Request for Quotation

RFQ NUMBER
WSH10002

LINE	QUANTITY	UOP	CAT NO	ITEM NUMBER	UNIT PRICE	AMOUNT
ADDENDUM NO. 2 1. QUESTIONS AND ANSWERS ARE ATTACHED. 2. ADDENDUM ACKNOWLEDGEMENT IS ATTACHED. THIS DOCUMENT SHOULD BE SIGNED AND RETURNED WITH YOUR BID. FAILURE TO SIGN AND RETURN MAY RESULT IN DISQUALIFICATION OF YOUR BID. EXHIBIT 10 REQUISITION NO.: WSH10002 ADDENDUM ACKNOWLEDGEMENT I HEREBY ACKNOWLEDGE RECEIPT OF THE FOLLOWING CHECKED ADDENDUM(S) AND HAVE MADE THE NECESSARY REVISIONS TO MY PROPOSAL, PLANS AND/OR SPECIFICATION, ETC. ADDENDUM NO. S: NO. 1 NO. 2 NO. 3 NO. 4 NO. 5 I UNDERSTAND THAT FAILURE TO CONFIRM THE RECEIPT OF TH

LINE	QUANTITY	UOP	CAT NO	ITEM NUMBER	UNIT PRICE	AMOUNT
0001	1	JB		990-22		
ACCESS CONTROL SECURITY SYSTEM						
***** THIS IS THE END OF RFQ WSH10002 ***** TOTAL:

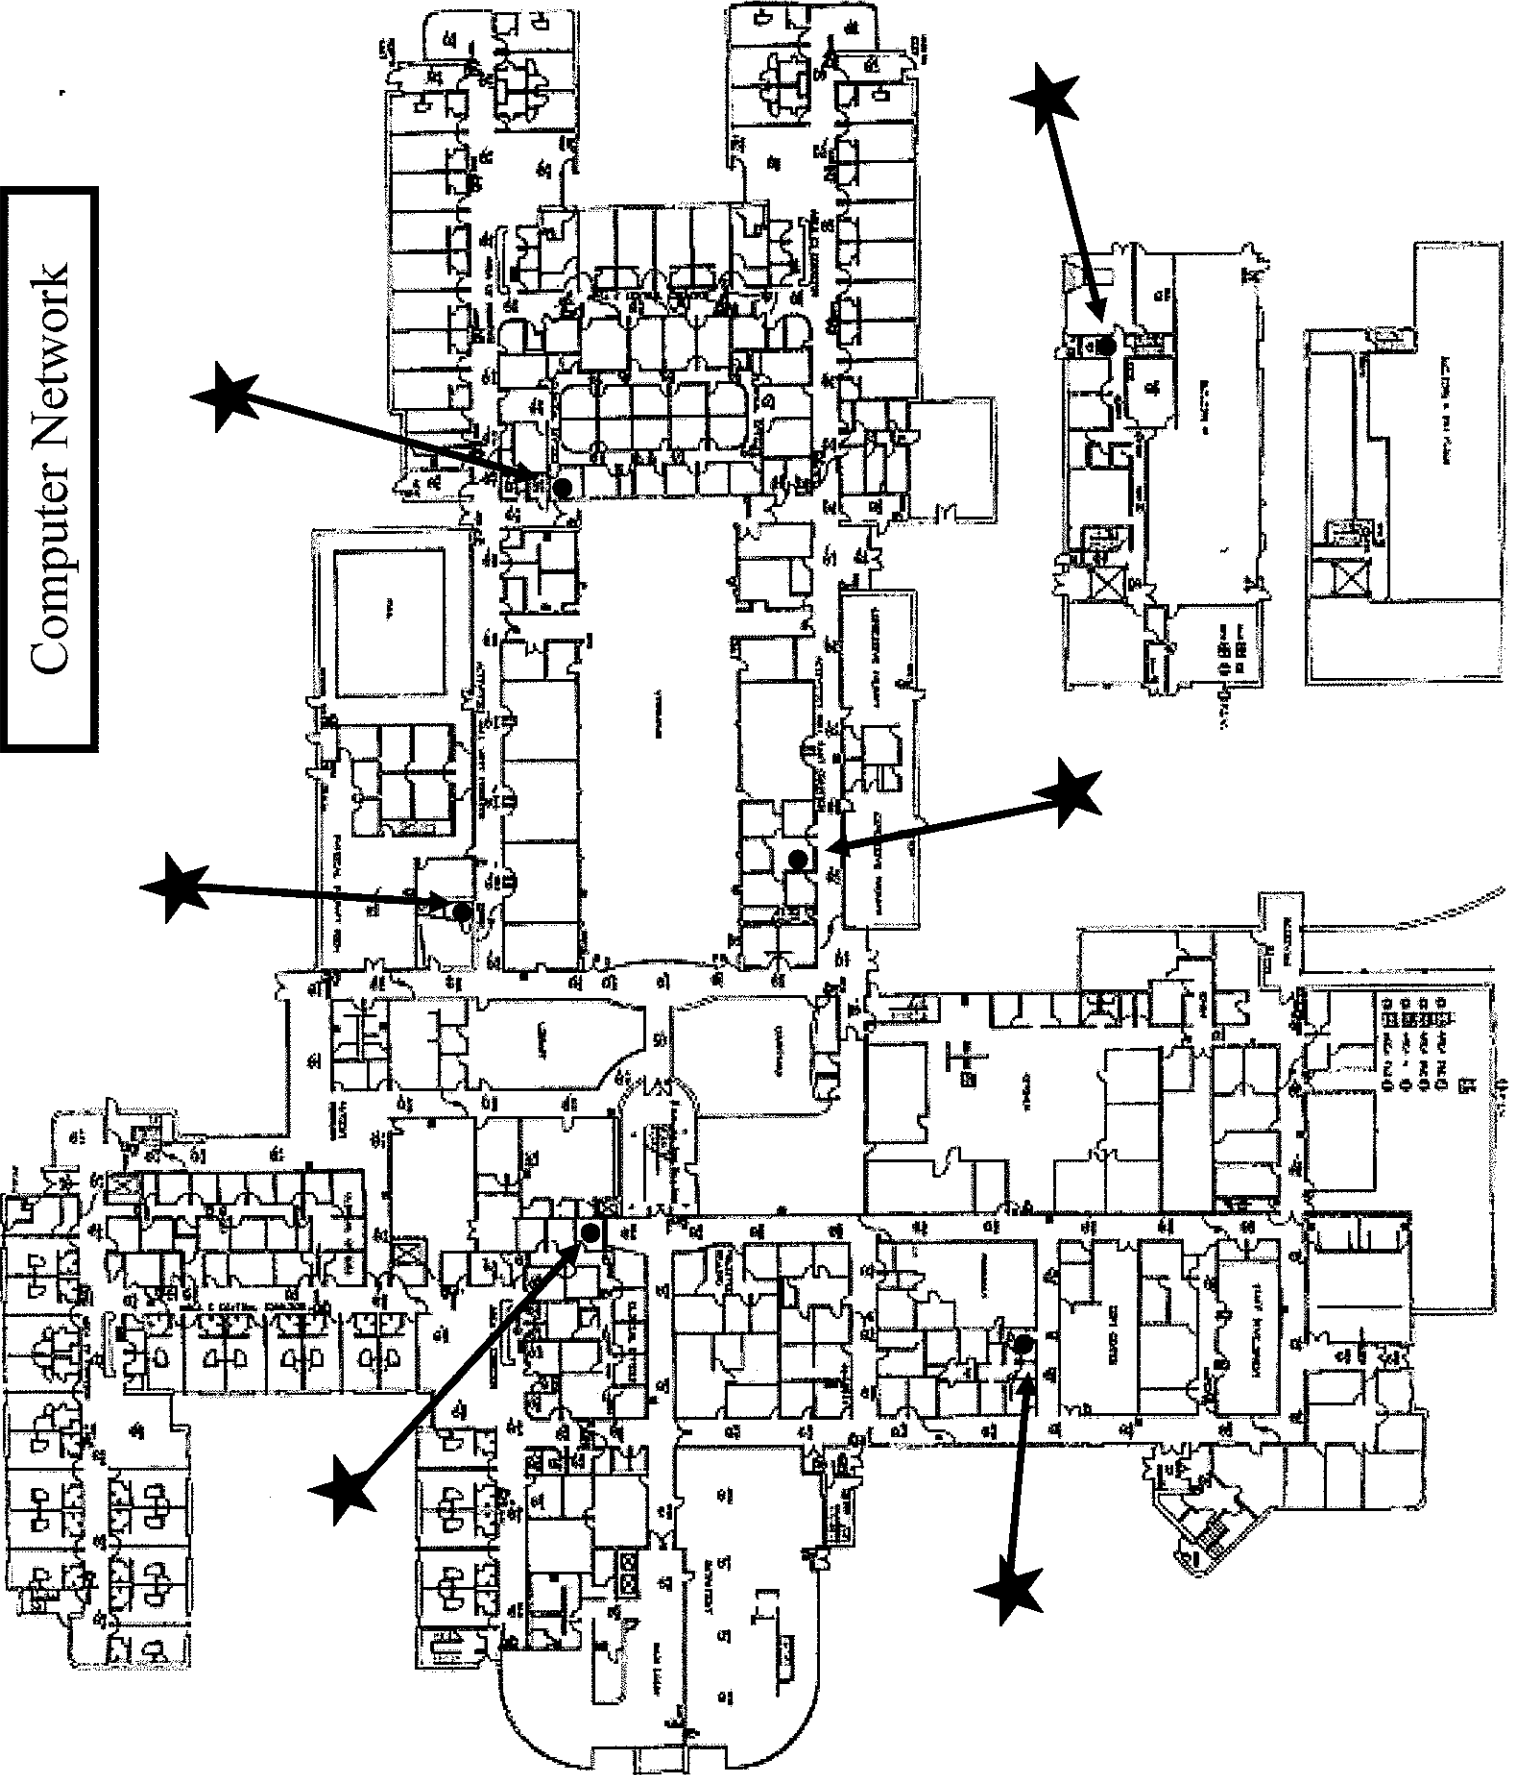
9. Are there any fiber optic cable runs between the various equipment room rack closets now and if so are there any spare fibers available and if so, is the fiber multi-mode or single mode?

Yes, there are fiber drops to the closets.

Yes, there are spare fiber pairs.

Multi-mode
